Access Compliance Report

Public Rights-of-Way

(Curb Ramps)

Intersection ID: 10031810	Main Street: MILLENNIUM_AV	Cross Street: N/A	Location: S
ADA ID: 184021263566	Ramp Type: Perp	Initial Pass/Fail: Fail	Overall Compliance: No
Severity Score: 12.5			
Codes/Mitigation Info/Possible Solution		Field Measurements/Component Compliance

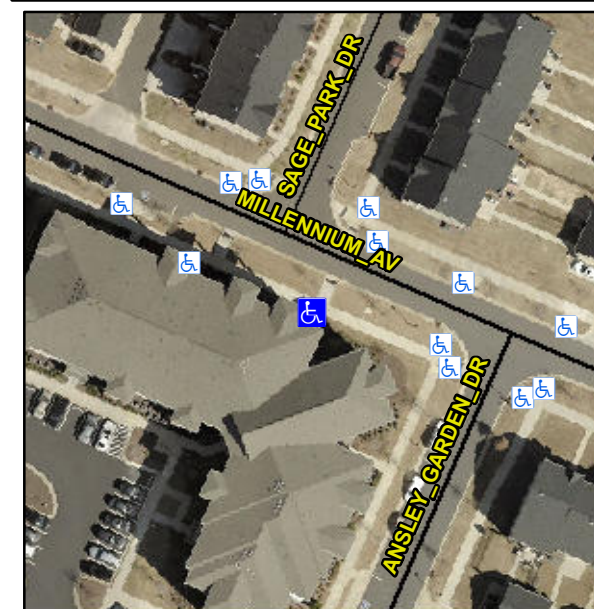
R304.2.2

Compliance	Description	Data	Compliance	Description	Data
N/A	Ramp Length (in)	161.0	No	Ramp Slope (%)	8.6
Yes	Ramp Width (in)	72.0	Yes	Ramp XSlope (%)	1.1
N/A	Flare Type LT	N/A	N/A	Flare Type RT	N/A
N/A	Flare Slope LT (%)	N/A	N/A	Flare Slope RT (%)	N/A
N/A	Flare Traversable LT?	N/A	N/A	Flare Traversable RT?	N/A
N/A	Landing Length (in)	N/A	N/A	DWS Provided?	N/A
N/A	Landing Width (in)	N/A	N/A	DWS Contrast?	N/A
N/A	Landing Slope (%)	N/A	N/A	DWS Length (in)	N/A
N/A	Landing X Slope (%)	N/A	N/A	DWS Full Width?	N/A
N/A	Landing Curb? (Y/N)	N/A	N/A	DWS Offset (in)	N/A
N/A	Shared Landing?	N/A			
N/A	Gutter Ponding?	N/A	N/A	Gutter Slope (%)	N/A
N/A	Gutter Lip Ht (in)	N/A	N/A	Gutter X Slope (%)	N/A
N/A	Painted X Walk1?	No	N/A	Painted X Walk2?	N/A
	X Walk 1 Direction	To NE		X Walk 2 Direction	N/A
N/A	X Walk 1 Width (in)	N/A	N/A	X Walk 2 Width (in)	N/A
	X Walk 1 Slope (%)	1.5		X Walk 2 Slope (%)	N/A
	X Walk 1 X Slope (%)	2.4		X Walk 2 X Slope (%)	N/A

Remove & Replace Entire Ramp.
